Connecticut Work Zone Reviews

Annual Report

2017

State of Connecticut
Department of Transportation
Office of Construction

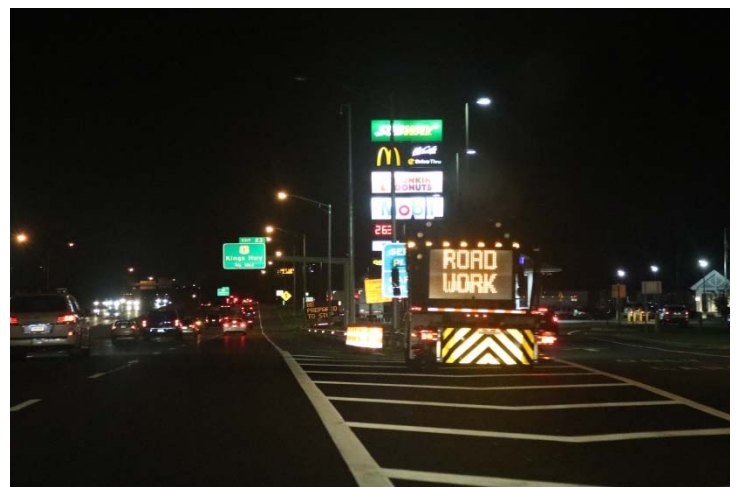
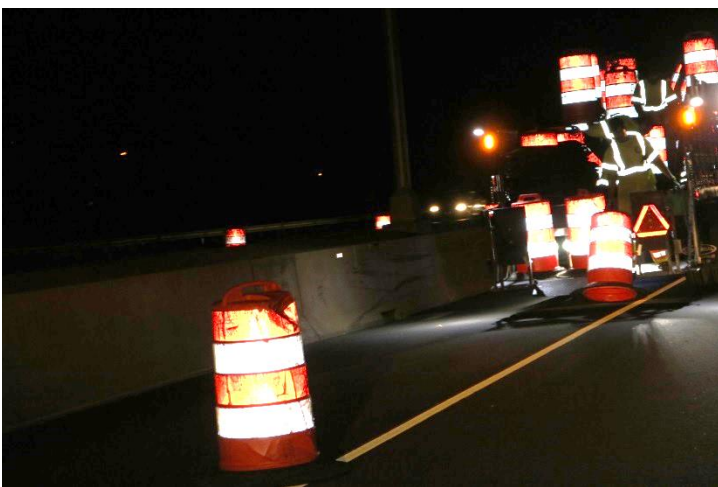
I-95 NB: This traffic drum is missing reflective tape and is marginally acceptable.

I-95 NB: This traffic drum is partially misshaped which is marginally acceptable.

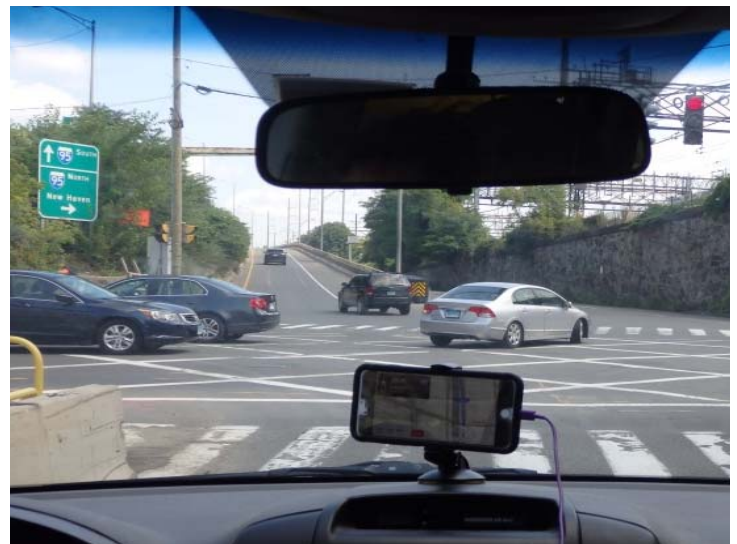
The edges of the H-piles used for the embankment support are unprotected and need to be protected as a blunt object.

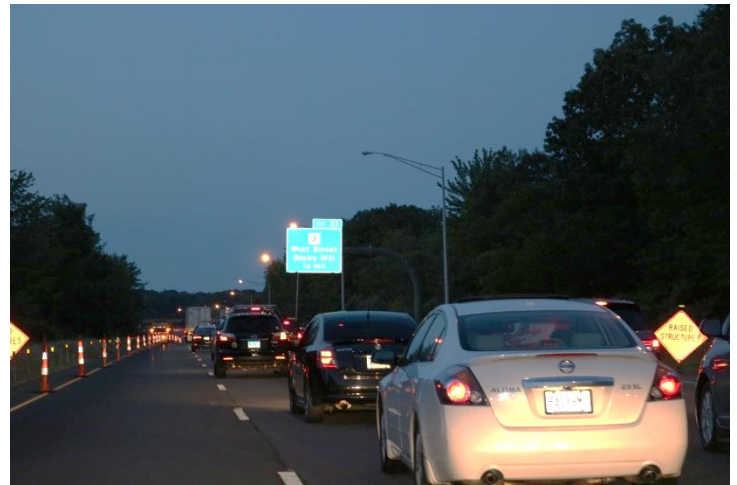
I-91 NB: A merge right depiction sign only on the left side of the road. None was placed on the right side of the roadway.

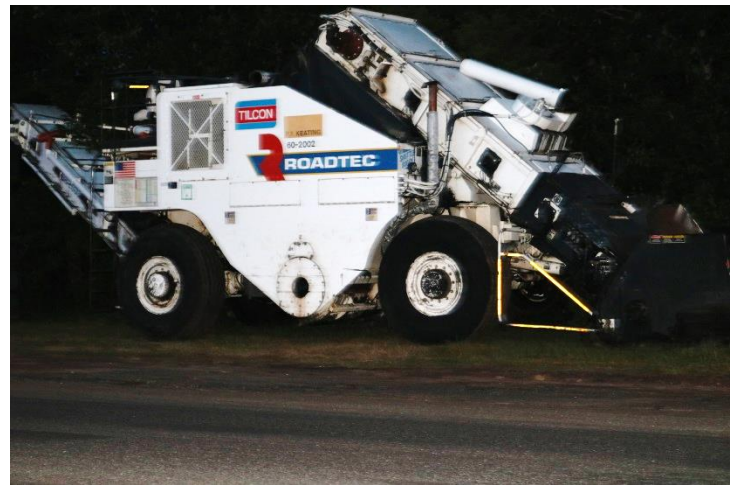
I-91 NB: The VMS over the northbound side didn't display any messages about the work zone below.

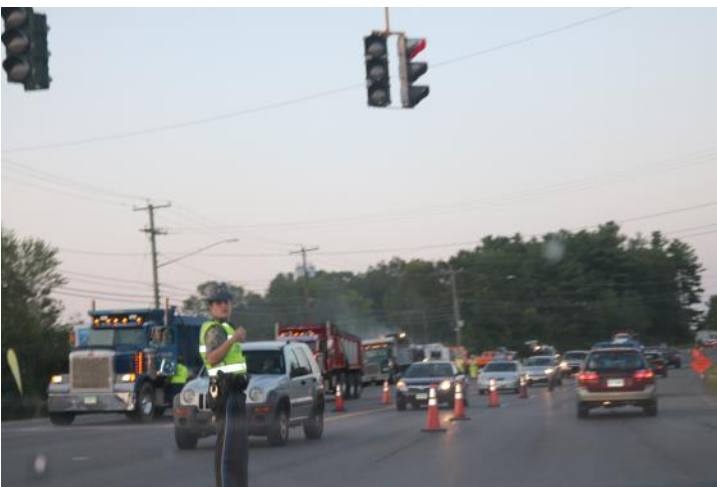
Route 6, Chaplin: The little arrow sign mounted after an intersection is been painted over and is unclear of what it's depicting.

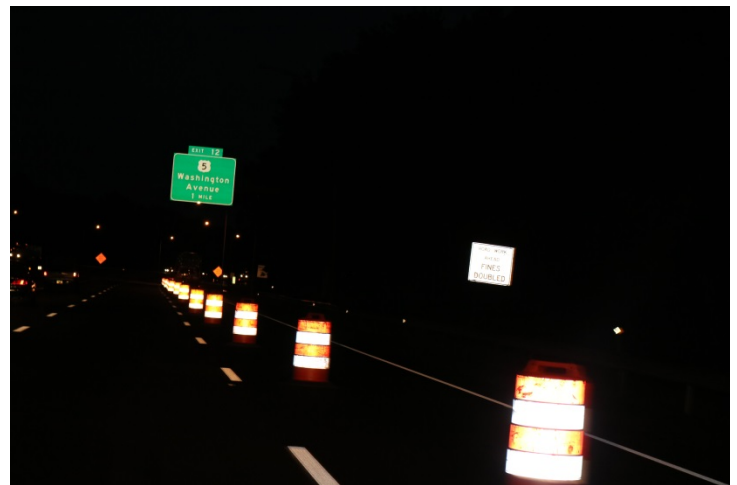
I-91 SB: A construction sign was knocked over after traffic was let through.

I-91 SB: The liability sign for the project is posted after the start of the pattern not before the advance warning signs closer to the project limits.
